NRC-04-023  
10 CFR 50.90

KEWAUNEE NUCLEAR POWER PLANT  
DOCKET 50-305  
LICENSE No. DPR-43

Responses To NRC Requests For Additional Information Regarding License  
Amendment Request 195, Stretch Power Uprate For Kewaunee Nuclear Power Plant  
(TAC NO. MB9031)

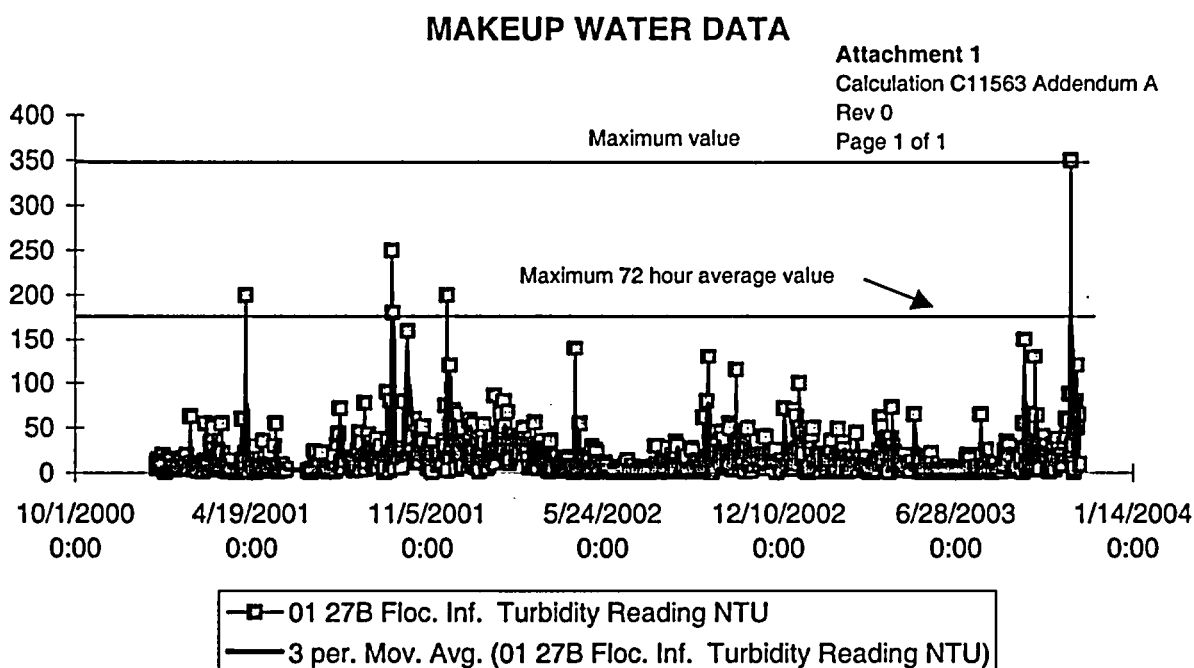
**NRC Question 1:**

Kewaunee relies upon the essential service water system for providing an assured source of water to feed the steam generators following postulated accident conditions. The steam generators will tend to concentrate impurities that are in the water such that they will collect and plate out on the steam generator heat transfer surfaces, moisture separators, and steam dryers, potentially impacting the ability of the steam generators to remove reactor decay heat and cool down the reactor coolant system. Given the complete range of aquatic substance and impurities that can be drawn into the essential service water system from Lake Michigan (e.g., lake weed and other forms of marine life, silt, minerals, debris, pollutants, and micro-organisms), describe in detail bounding analyses that have been completed, test data that are credited, steam generator specifications and data sheets, and other applicable information that demonstrate that the Kewaunee steam generators will be able to perform their safety function over the longest mission time that is assumed in the plant design basis following stretch power uprate, when essential service water is used as the source of steam generator makeup water.

All the Lake Michigan turbidity data from 2001 through 2003 was analyzed and then plotted. See makeup water chart below. A trend line analysis was performed to take the average of three daily data points (72 hours). This produced a maximum average 72-hour value of 175 ppm Total Suspended Solids. This maximum 72-hour value is included on the makeup water data chart below. The 175-ppm TSS value was used to perform a sensitivity calculation using the same methods and other assumptions used in Calculation C11563, except for the TSS, and determined that the added solids would reduce the efficiency of the steam generators to 78.775%. Then NMC took the maximum value observed over the 3-year period of 350 ppm and performed a similar calculation. This reduced the efficiency to 71.504 %.

NMC performed these additional calculations<sup>[7]</sup> to show that even with the conservative assumptions included in the calculation of steam generator fouling, if the worst case turbidity results were used in the calculation the steam generators would still be able to remove greater than 2% reactor thermal power, the amount of power the reactor decay heat quickly drops to following a reactor trip. Note also that the reactor decay heat continues to drop as the nuclear fission daughter products decay away.
